Analysis of EU policy proposals for DG ENER Lot 12 Commercial Refrigeration

Including comparison with policy thresholds and product data from other regions

21 August 2014

Figure S1. Comparison of proposed EU MEPS and label boundaries with normalised data from Eurovent certification data for 2014, California (CEC), Australia and the UK Energy Technology List, showing vertical, remote open cabinets of temperature M2 (chilled).

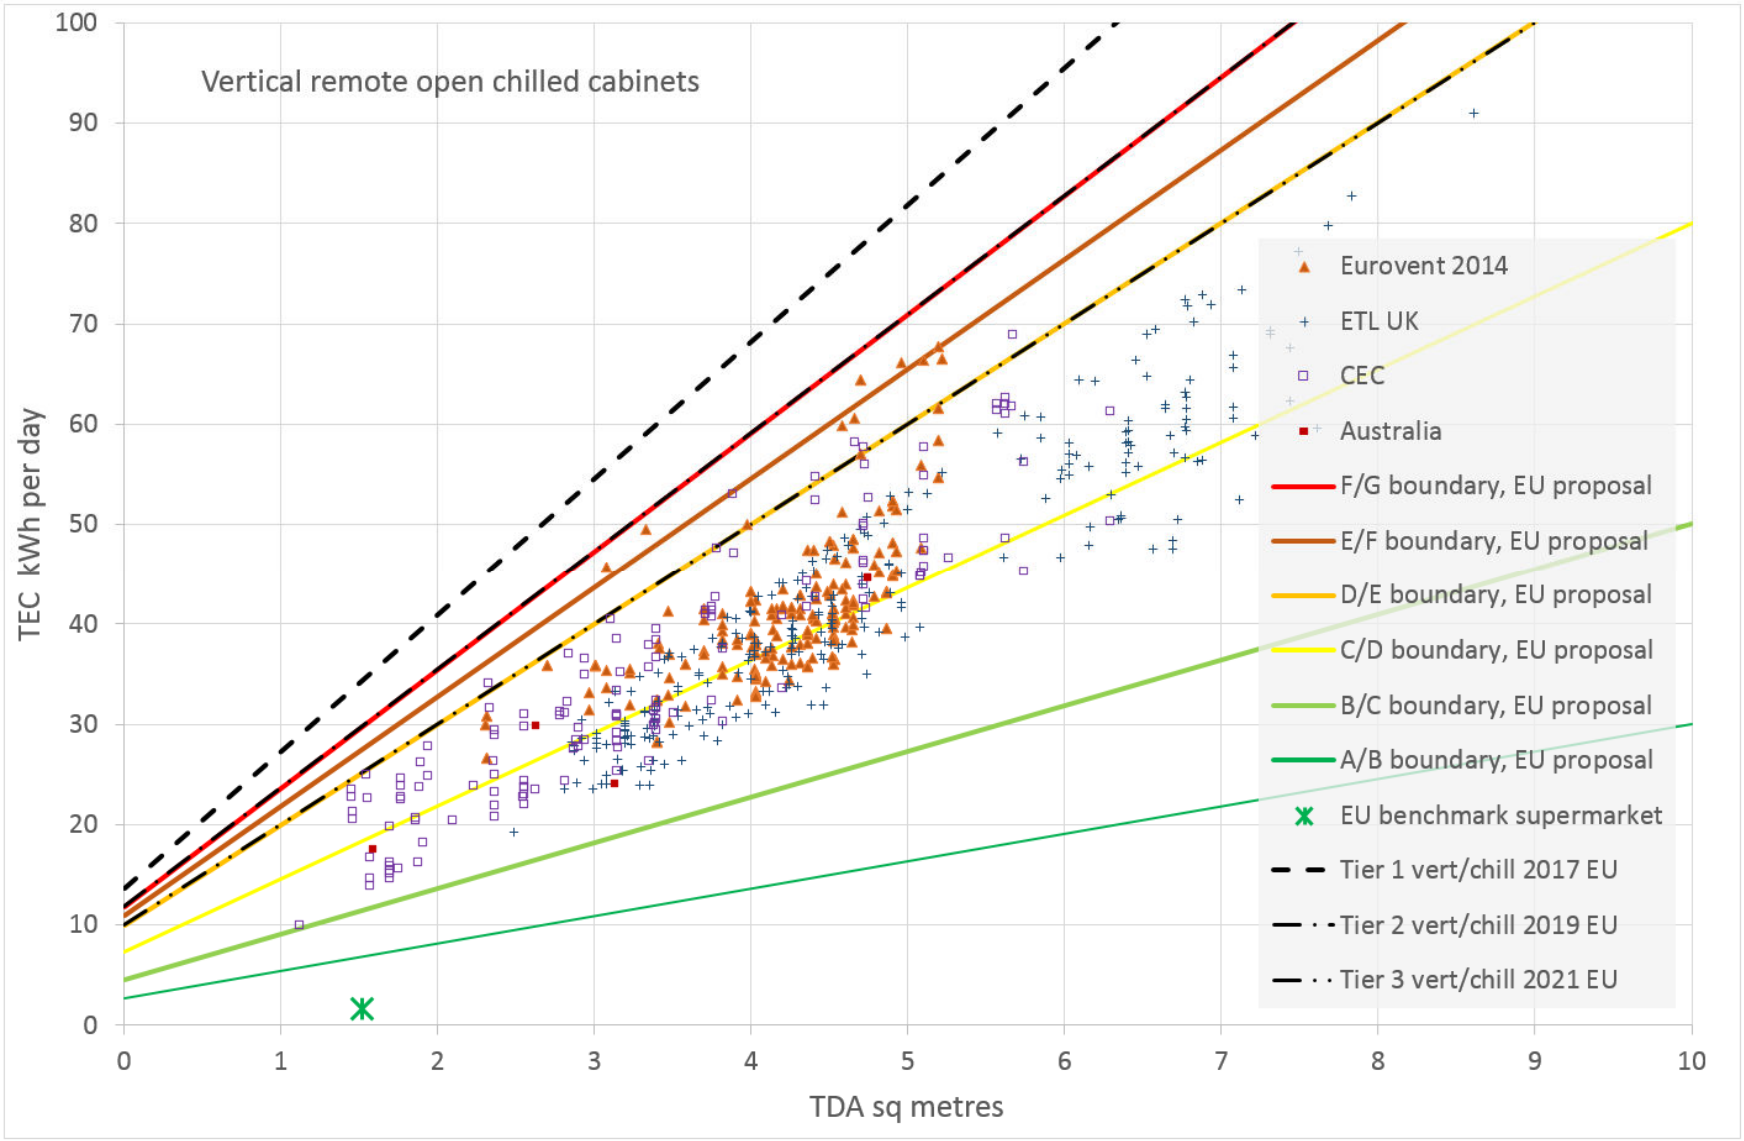
Using the normalised data, as seen in Figure S1, the 2017 EU MEPS are approximately 20% less demanding than the MEPS adopted 8 years earlier (2009) by the US DOE. The most ambitious EU requirement, Tier 3 which takes effect in 2021 is about 8% less demanding than the 2017 standards for the USA. If the proposed draft working document is adopted without modification, Europe would be years behind the USA with less stringent requirements. Furthermore, the Australian MEPS that became effective in 2004 for vertical multi-deck cabinets are more demanding than EU proposals for 2017 for small and medium sized cabinets; cabinets considered high efficiency in Australia in 2004 would easily meet the 2021 EU proposed MEPS. And finally, if it is a policy intention to move the market towards the use of closed cabinets, then the proposed EU MEPS will not achieve this since a significant portion of current open cabinets will remain unaffected.

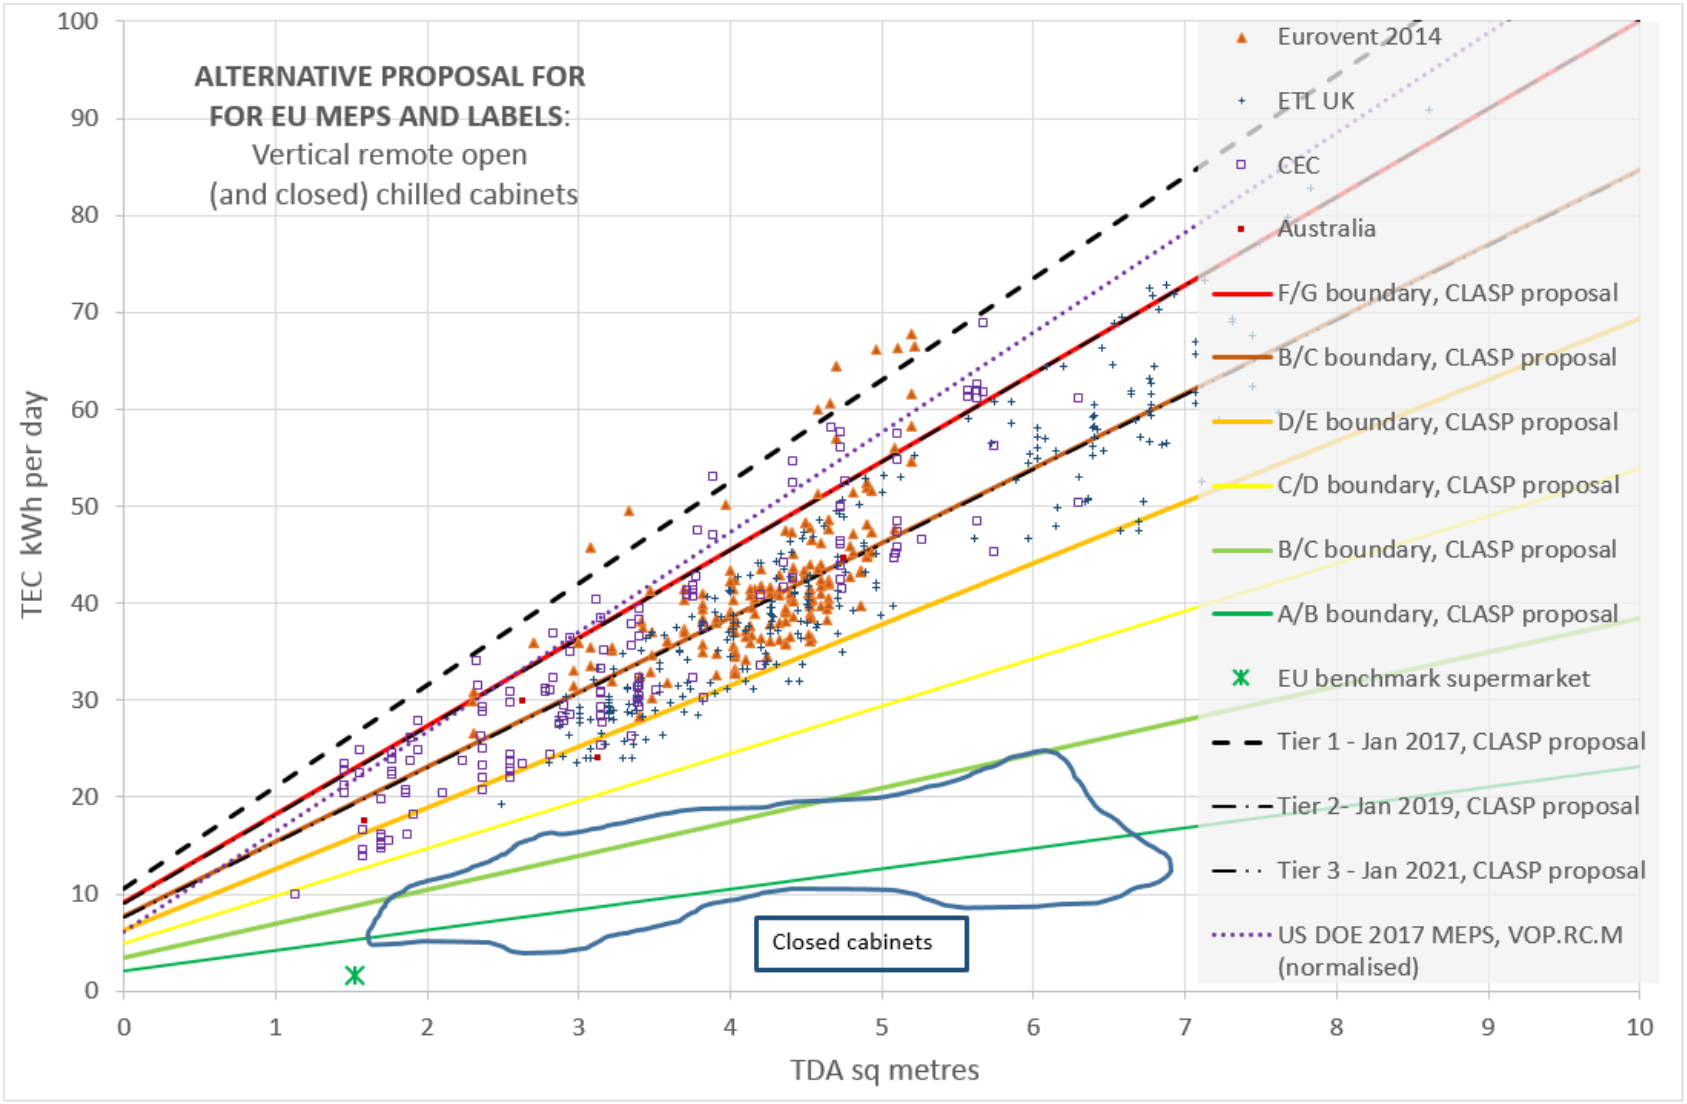
A revised reference line, label classes and MEPS levels is therefore proposed for vertical chilled cabinets as in Table S1 and shown in Figure S2, with the following benefits:

1. The label classes ensure continued differentiation of best cabinets into the future.
2. More even distribution of classes F, E and D means more scope to differentiate the current majority of open cabinets, so better encouraging progress.
3. The majority of open cabinets on the EU market would be energy labels E, F and lower and so would discourage their use.
4. It ensures that the EU industry is globally competitive on energy efficiency.
5. MEPS ensure significant improvement in the performance of open cabinets and will allow the best open cabinets to remain on the market after 2021 for use in applications where they are necessary.

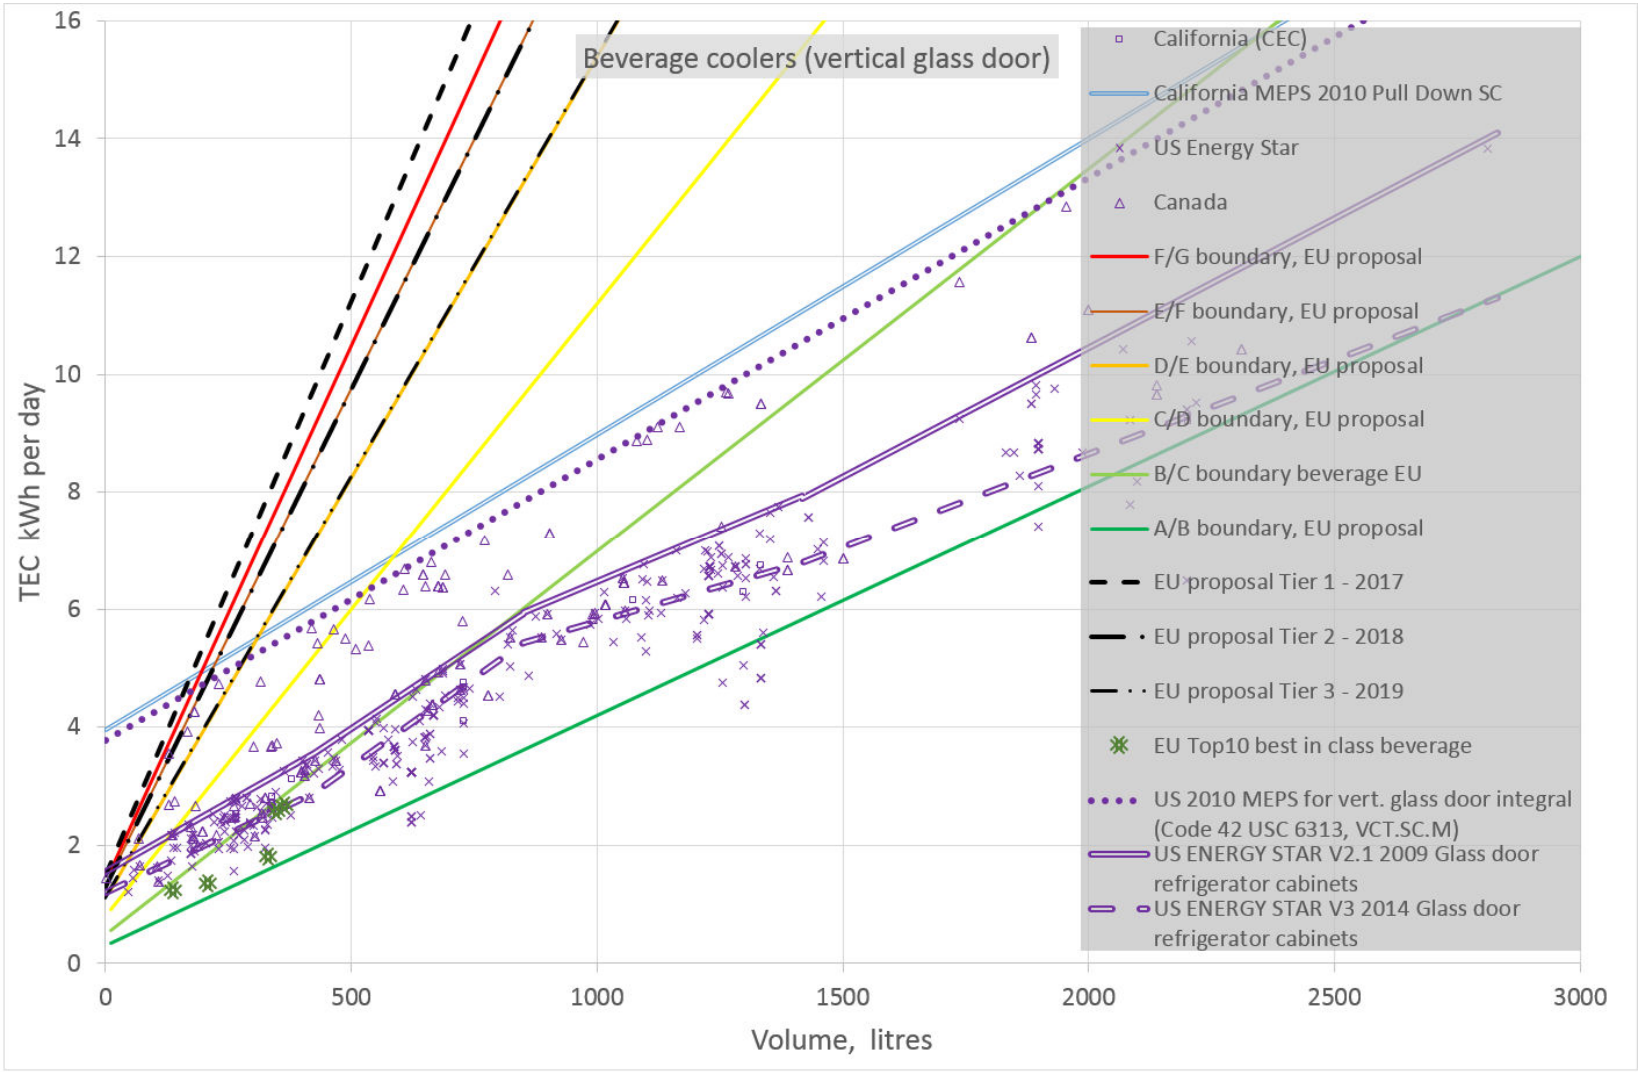
If the proposed draft working document is adopted without modification, the normalised data implies that the general slope of the energy performance versus volume lines in the EU proposal for beverage cabinets appears to be problematic. It is stringent on very small cabinets but has no effect on larger cabinets (see Figure S3). The lines are also significantly different to the slope deemed appropriate for all US regulations. Furthermore, the lower classes are very narrow (a small adjustment in volume could easily shift the cabinet by one energy class or more). Since classes A and B are very broad, differentiation of products in future years will be harder and this brings a risk that the bulk of the market could stall at class B (due to the disincentive of investing in a big jump in performance up to efficiency class A). Compared to the US MEPS from 2010, a standard full height single glass door cabinet under the 2017 EU requirements is allowed nearly twice the energy consumption of a similar cabinet in the US. Even the 2021 EU requirements for this popular size allows 25% higher consumption than the US MEPS from 2010 – implying that the EU market would be allowing efficiency levels over *15 years behind those of the US*.

Figure S4. An alternative scheme of MEPS and label thresholds for the EU, compared with criteria for USA (DOE MEPS for glass door vertical cabinets 2010, beverage cabinet MEPS for 2017 and US ENERGY STAR V2.1 criteria (2009) with ENERGY STAR V3 criteria (October 2014).

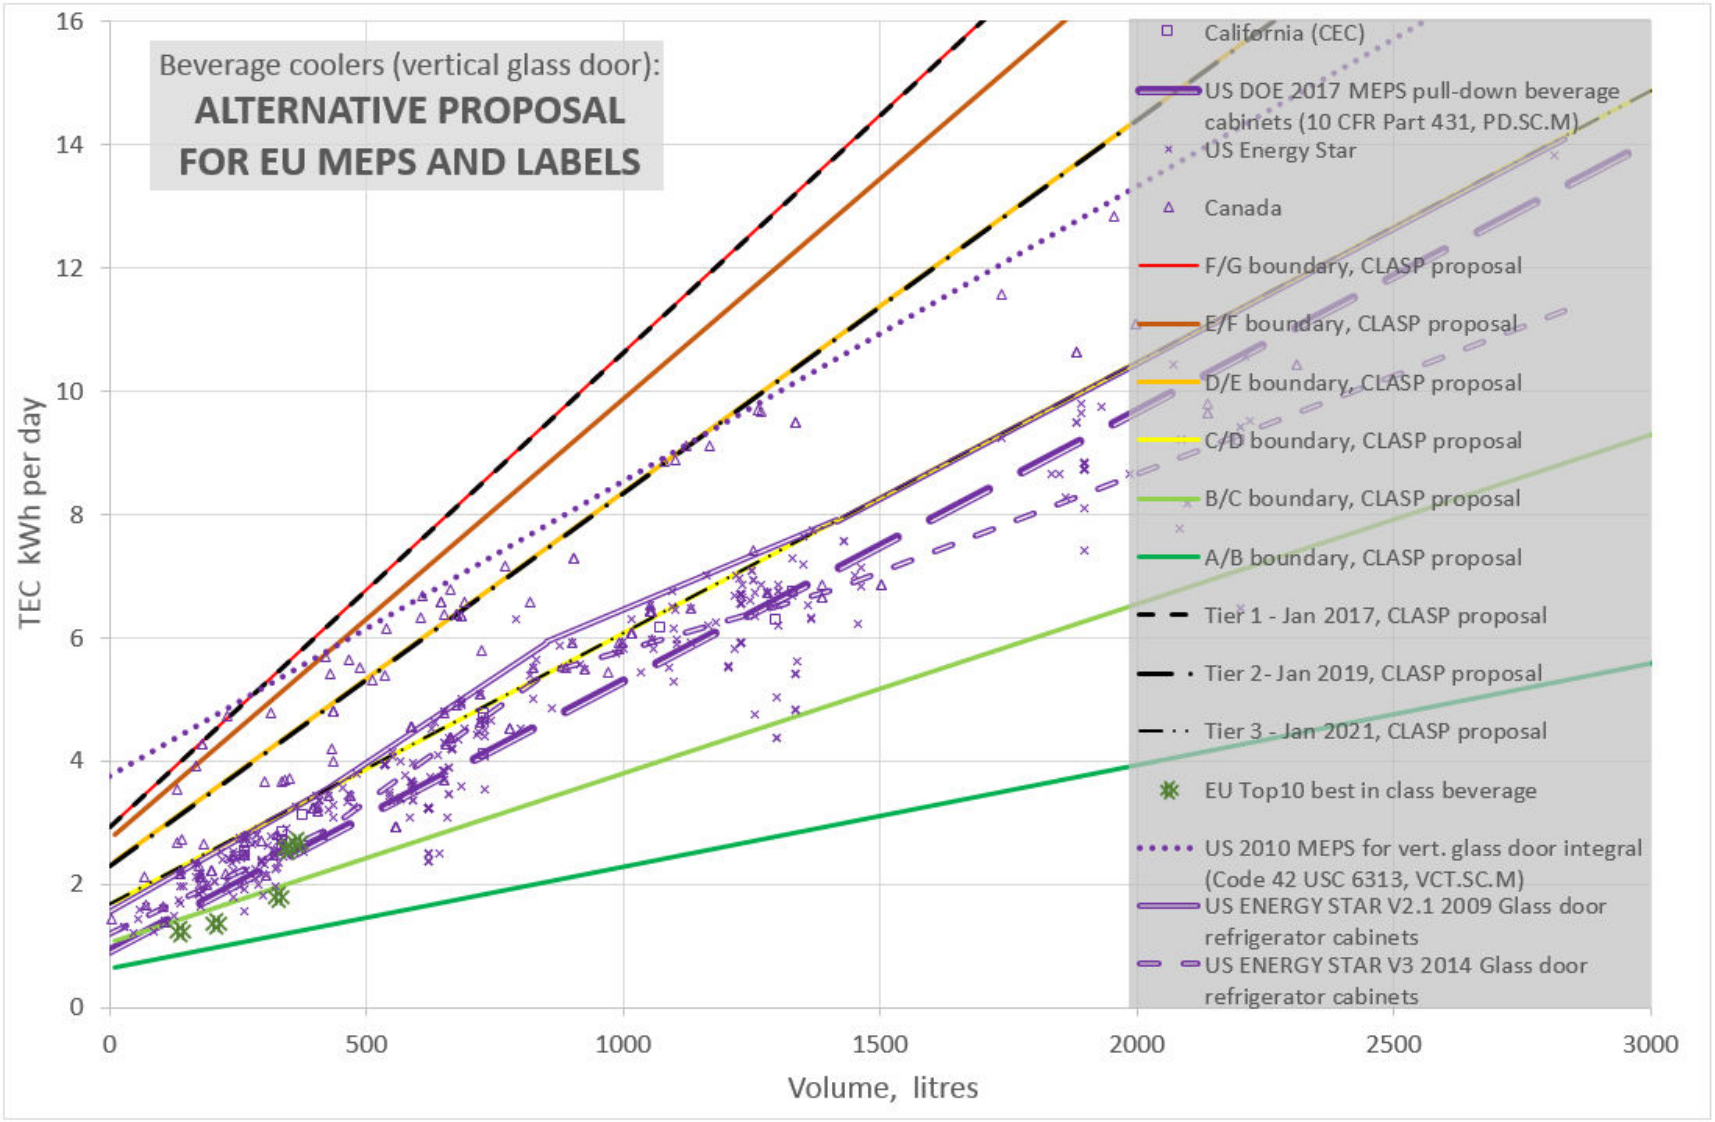
To address some of these issues, possible alternative MEPS for beverage coolers are proposed in Table S2 and Figure S4. These levels will have an impact on cabinets across the whole size range and give scope to encourage further improvements by having no cabinets currently in class A. With the alternative proposed Tier 2 in 2019, the EU market would be better than the US market of ten years earlier (2010). EU Tier 3 of 2021 is almost identical to the ENERGY STAR requirement of 2009 (12 years earlier). Arguably 2021 stringency could be further increased since it still allows 30% higher consumption than the US MEPS of 2017 (4 years earlier), but this should be reviewed after 3 years once data from the new EU test method is established.

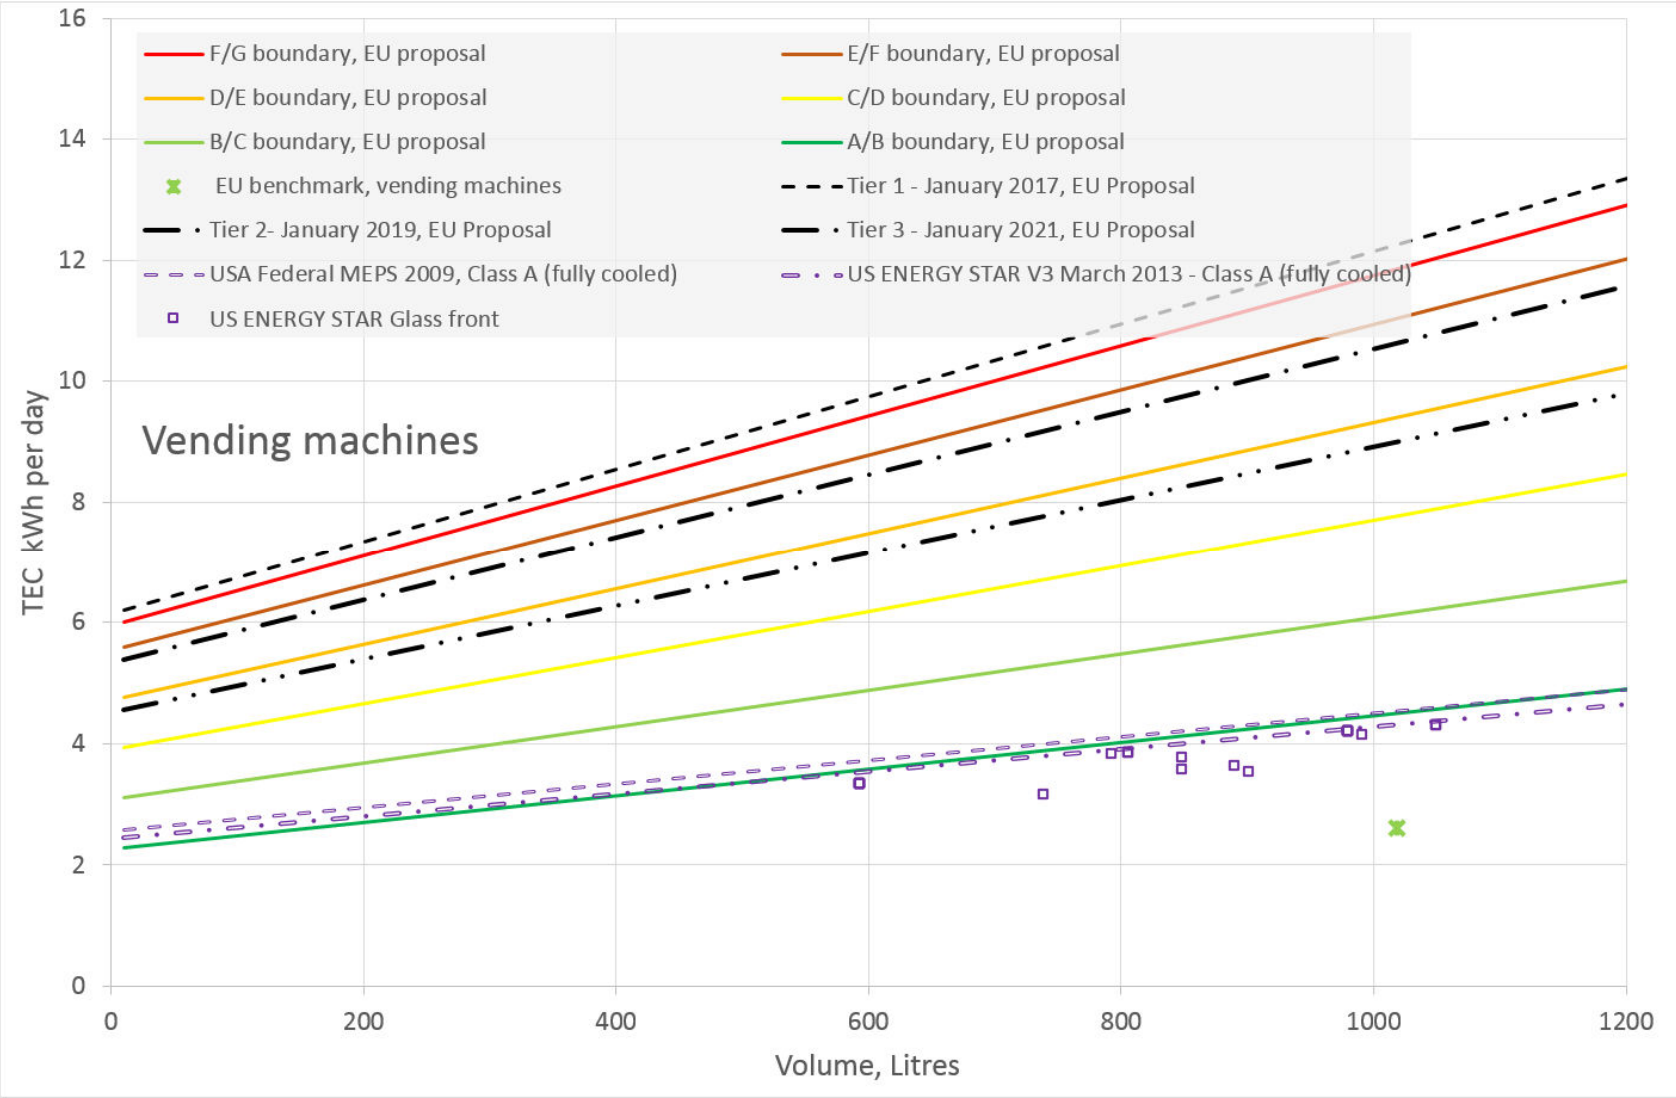
The proposed EU MEPS and labels are shown in Figure S5: the proposed EU MEPS do not coincide with any label levels which is potentially confusing and MEPS could easily be aligned with the G, F and E label thresholds. On stringency and if the proposed draft working document is adopted without modification, even the 2021 requirements for the EU allow twice the energy consumption per day of US MEPS that became effective in August 2012. The reason for this large difference is not clear, but evidence indicates that a significant portion of the EU data set may be outdated or unreliable – especially since there is no significant difference in the basic technologies employed in the products.
